AGENDA
CITY OF TAYLOR, TEXAS
PLANNING & ZONING COMMISSION MEETING
CITY HALL COUNCIL CHAMBERS
400 PORTER STREET, TAYLOR, TX 76574
AUGUST 13, 2024, 6:00 PM

Staff has completed its review of plans for the 3311 W 2nd St - Minor plat that is to be located at 3311 W 2nd St, Taylor 78626. Staff's recommendation is for Denial at the August 13, 2024, Planning and Zoning Commission Meeting. There are corrections that need to be made prior acceptance of the plat. Comments from this review follow.

**3311 W 2nd St.
Neighborhood Plan
Minor Subdivision Plat
Approximately 1.7 acres**

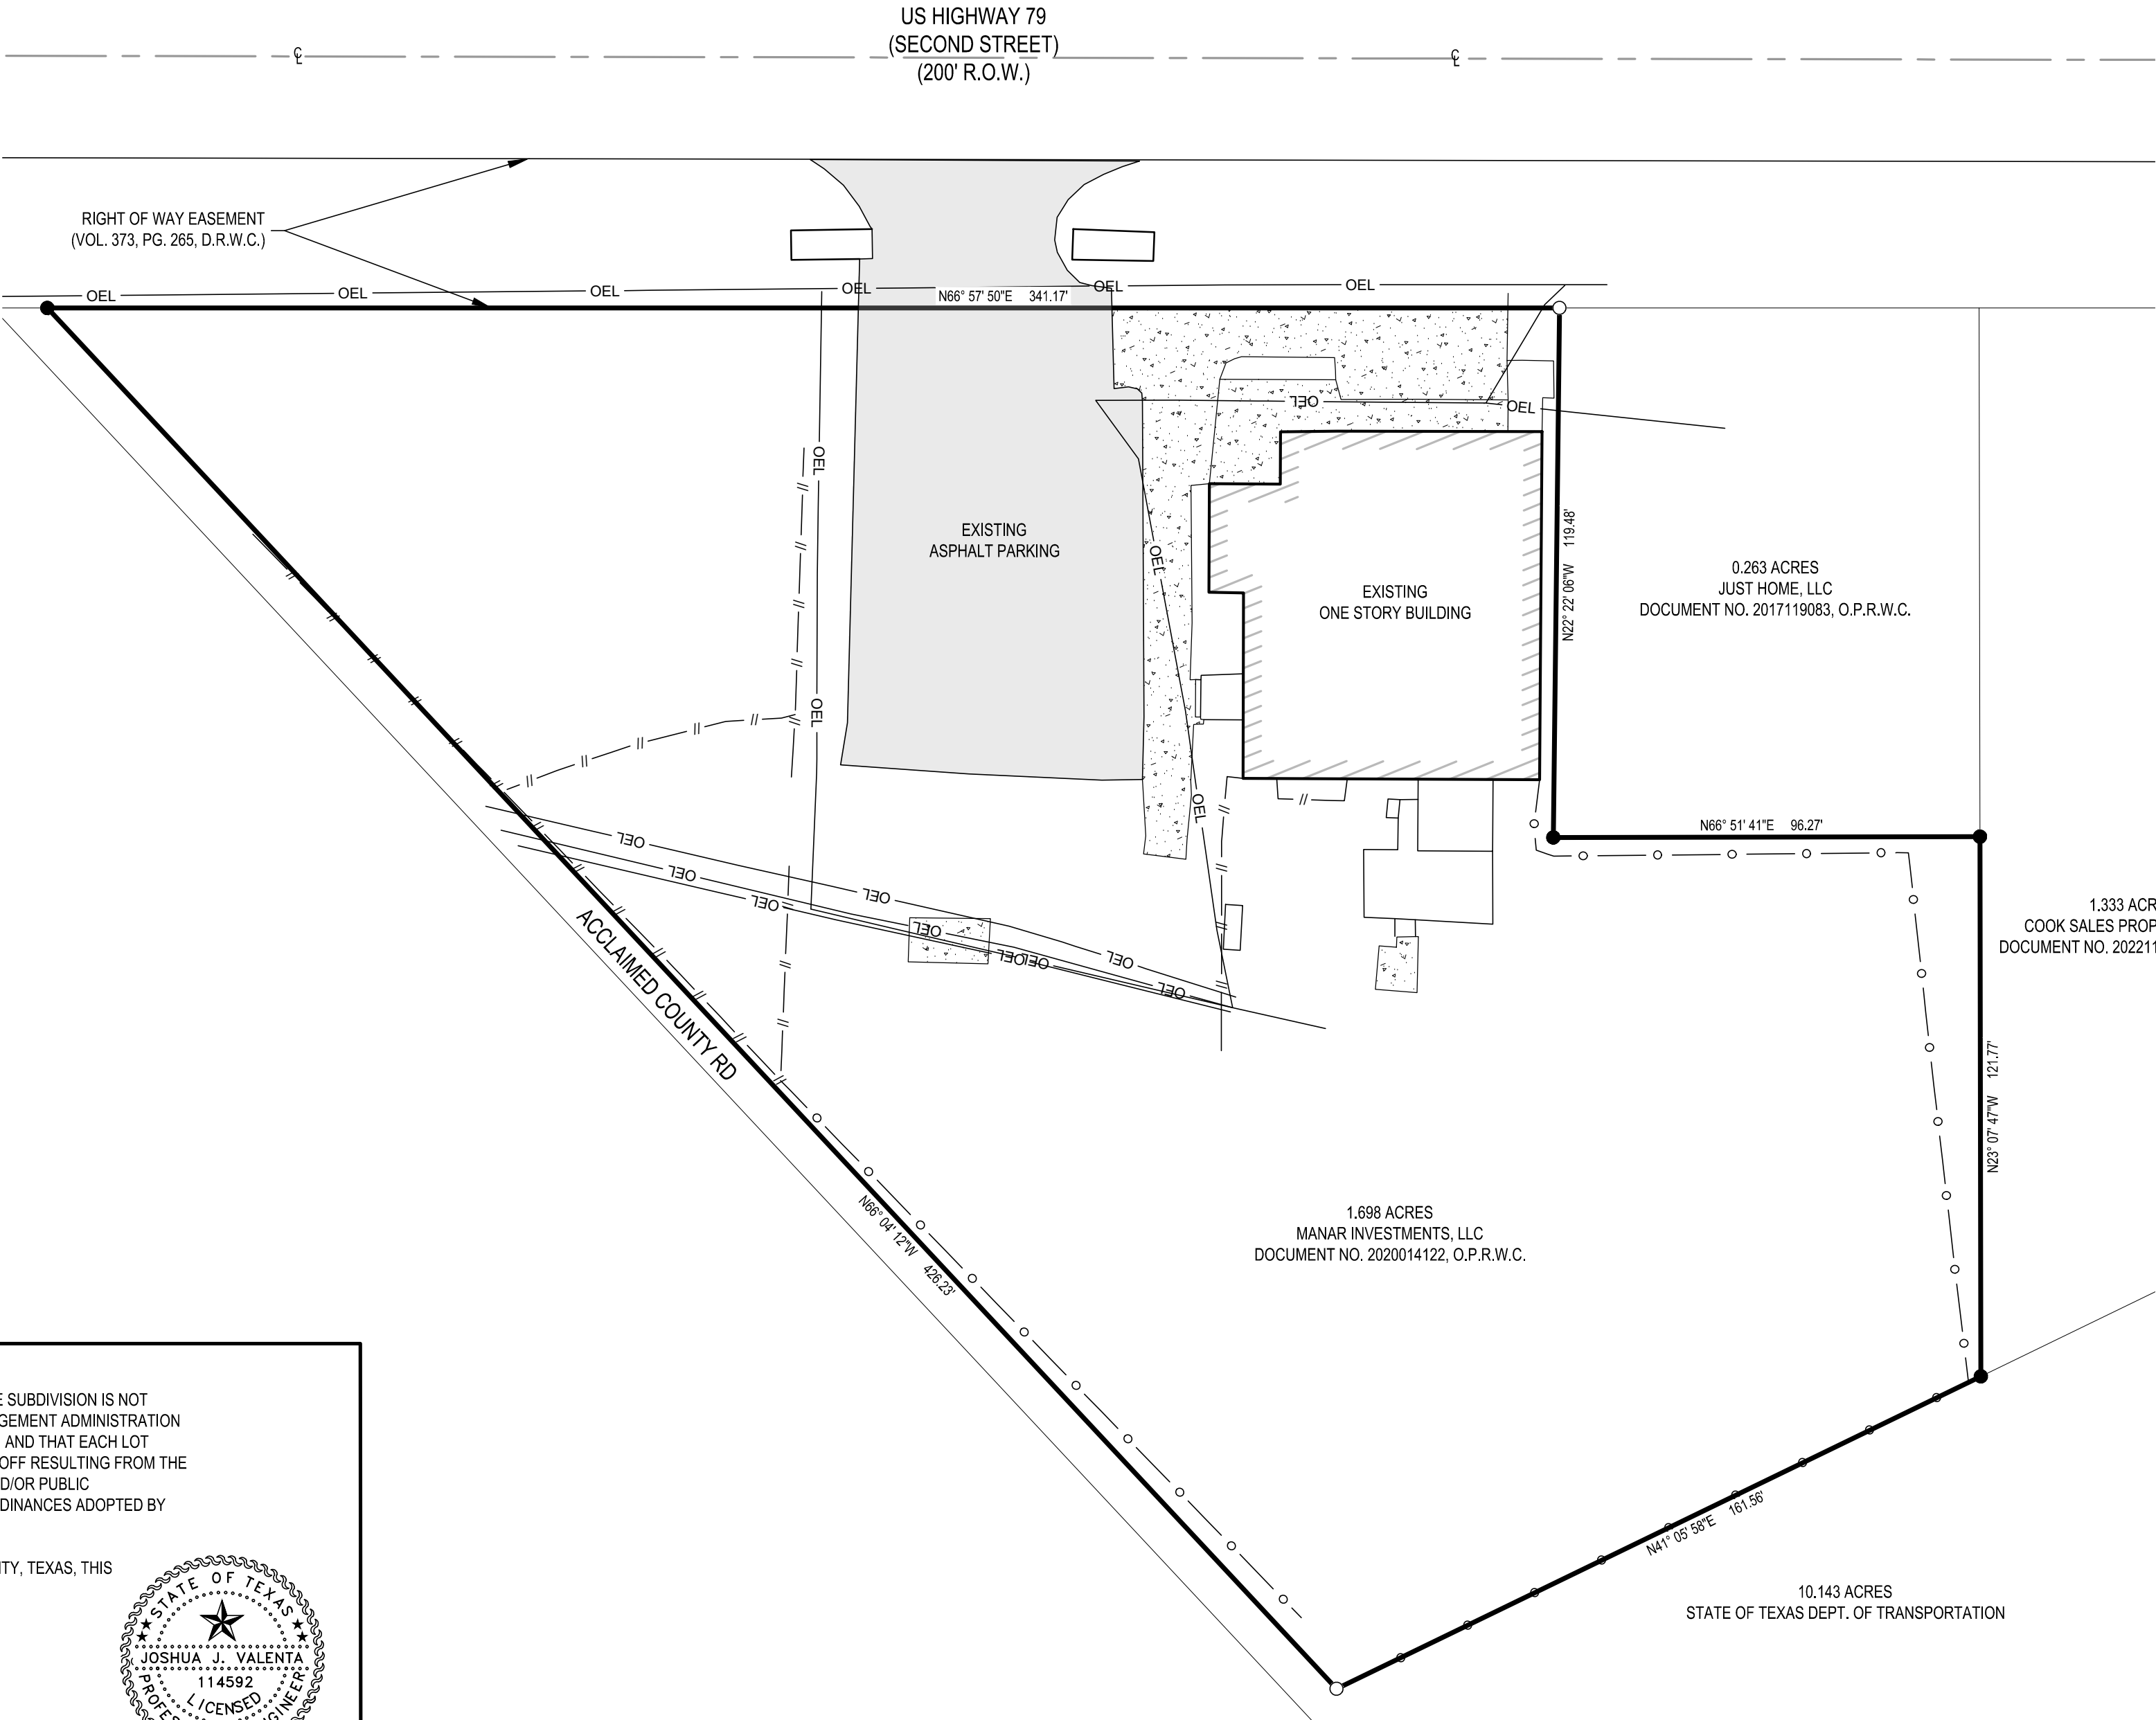
1. Revise project number to PZ-2024-2182
2. include the ROW acreage being dedicated and provide the lot and block numbers in the title
3. provide the field notes and descriptions of the boundary survey with bearings and distances

4. provide the name and title of signer if applicable and the address and phone number
5. move the north arrow and scale from preparer information
6. label the point of beginning of the plat that matches the point of beginning identified in the field notes

7. label the proposed lots and block on the plan view
8. add the square footage of the lot to the acreage label
9. show Topographic features, with ten (10) foot contour lines

12. label the iron rods found
13. provide notes on this plat that the monuments of this plat have been rotated to the NAD 83/93 HARN - Texas Central Zone and NAVD 88.

1. Complete plat heading information missing on the plat.
2. Provide metes and bounds field notes description.
3. Label the proposed lot and block information on the plat drawing.

5. Do not show existing features on the plat drawing such as the parking or buildings currently shown.
6. Update Engineer Certification to revise "Registered" to "Licensed".

7. Revise Surveyor's Certification to use plat certificate language found in the City Plat Application.
8. Provide a Development Services Director Certification block.

11. Show complete information for adjacent tracts (TxDOT) and County Road shown. Show Parcel information for other side of County Road shown.

Sheet 1 of 3

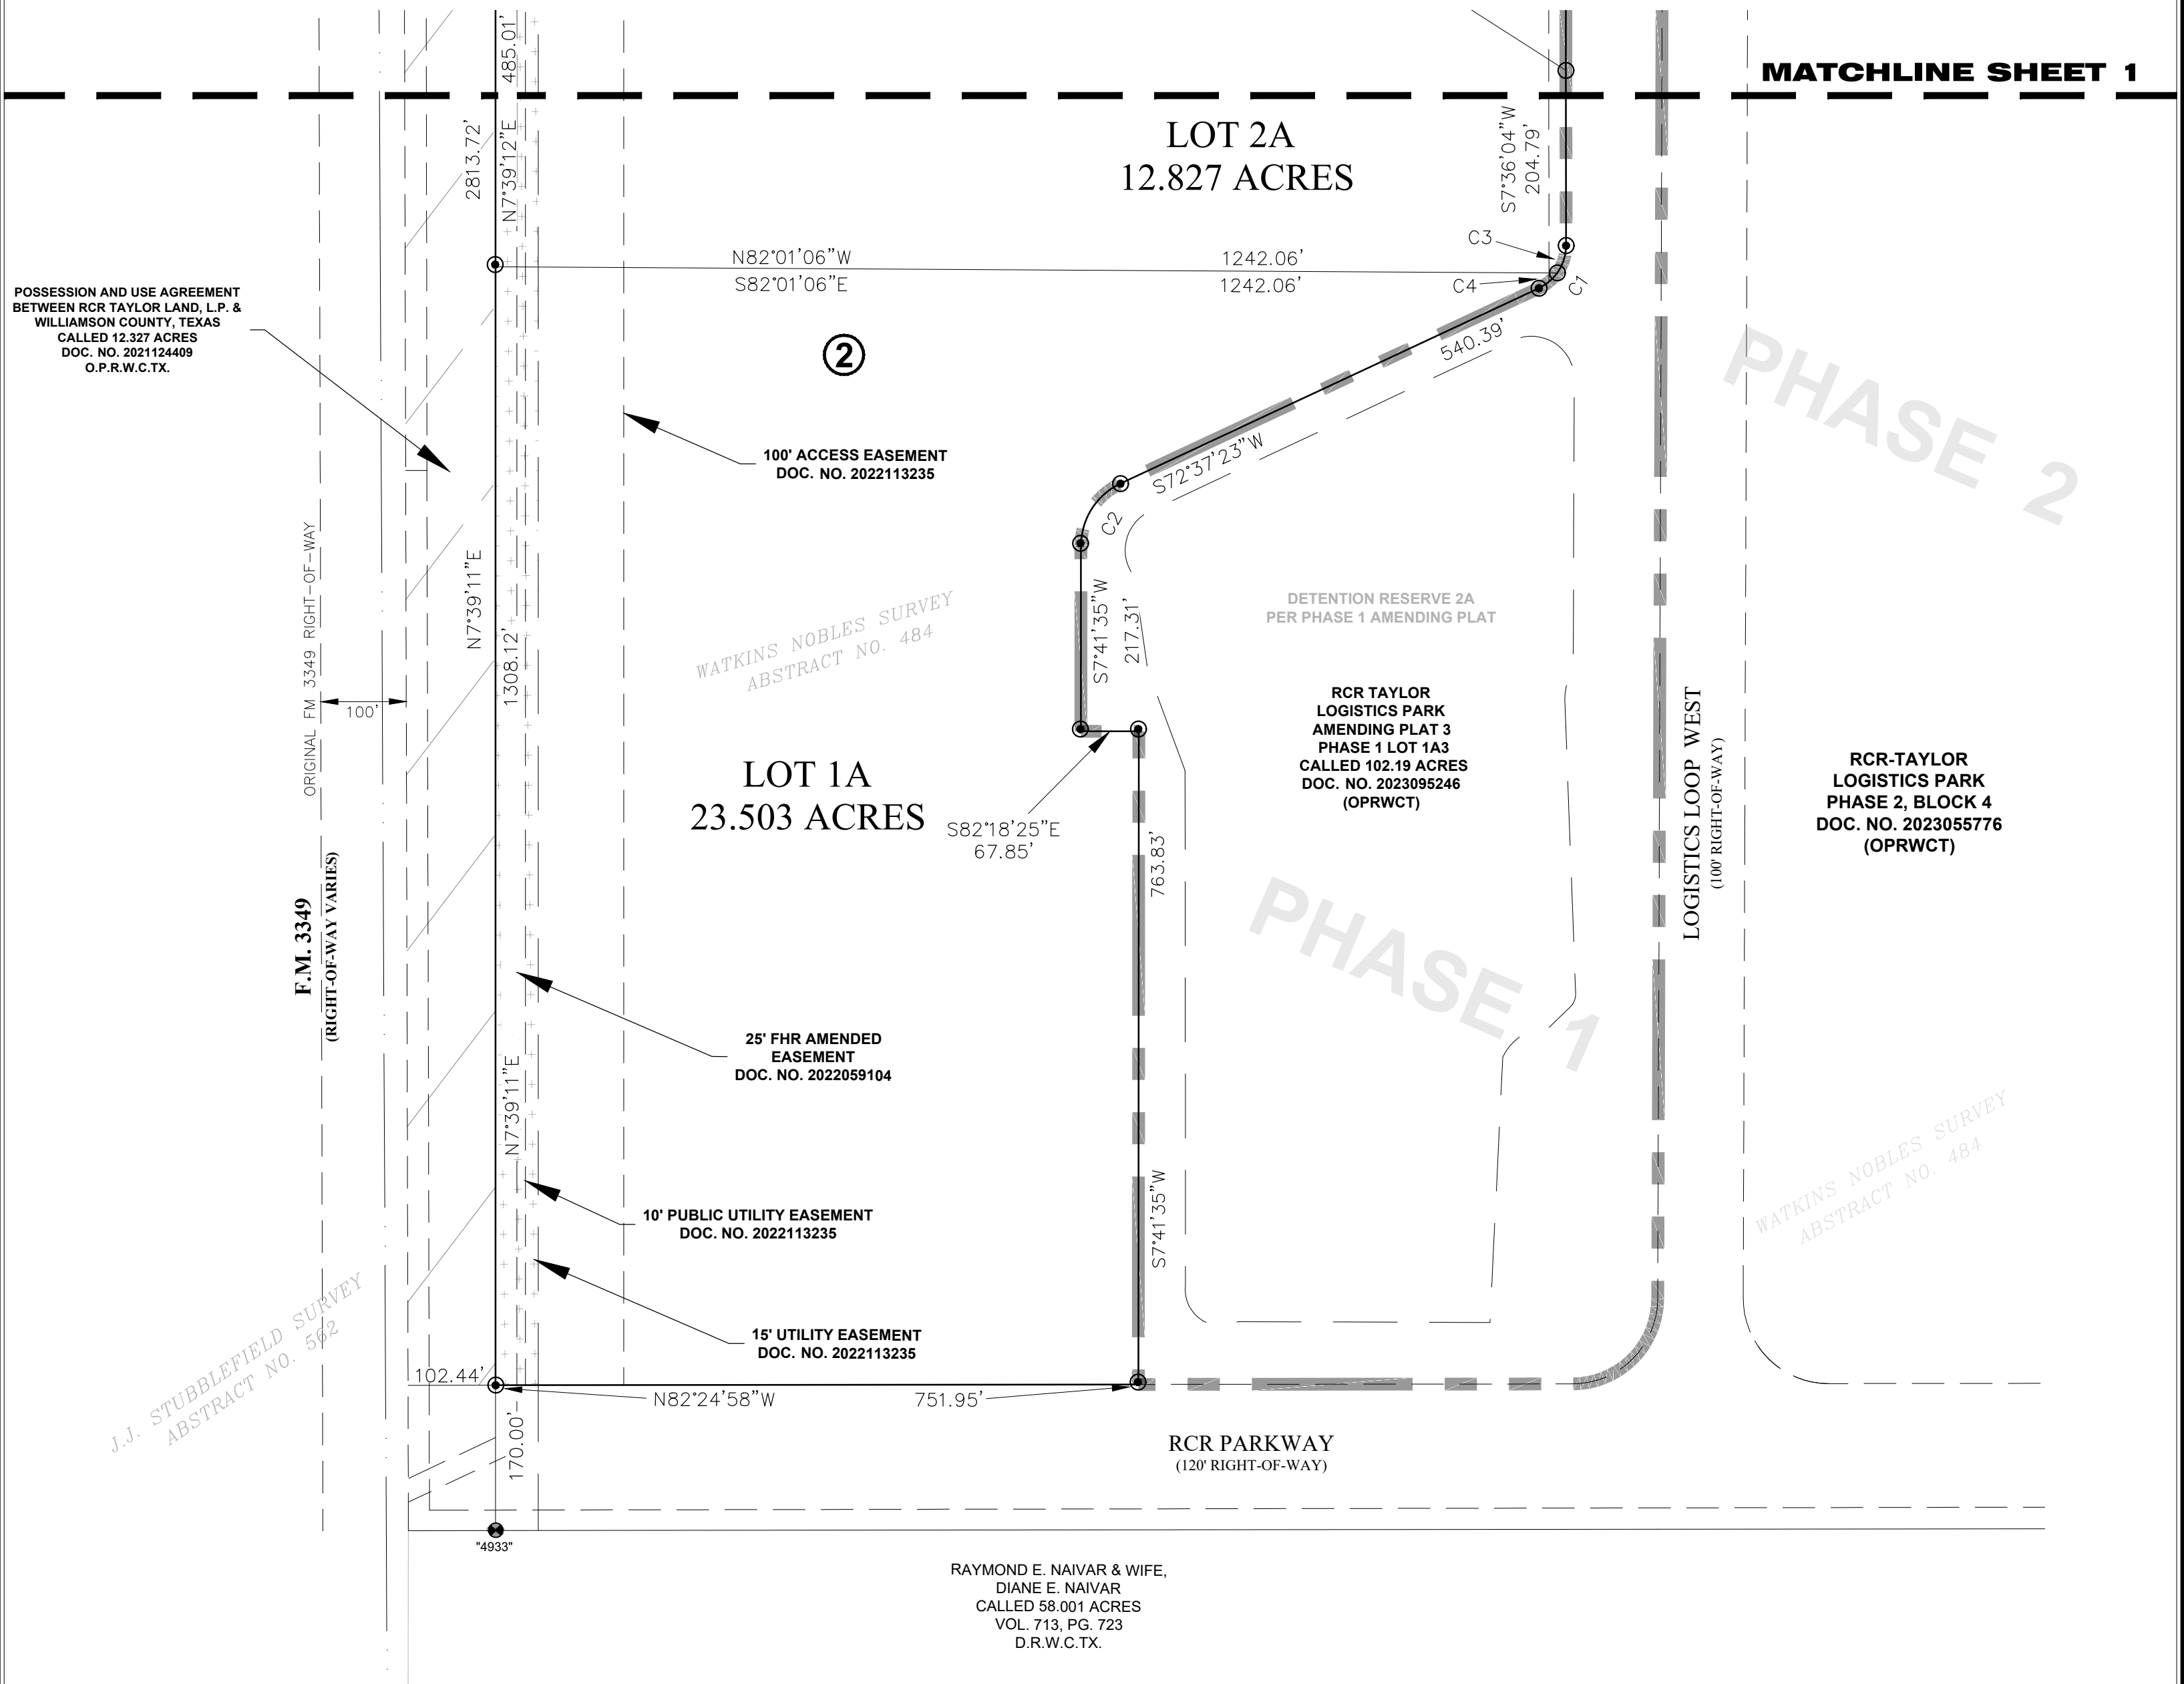
1. Move Legend for clarity of plat drawing.
2. Verify and notate locations of necessary drainage easements on Lot 3AA and Lot 2A that drain towards Detention Reserve 2A shown on sheet 2.
3. Provide plat perimeter in a bolder line weight to distinguish from boundaries outside the plat
4. Recommend adding dimensioning of the easements shown or use of an inset as used on previous replats
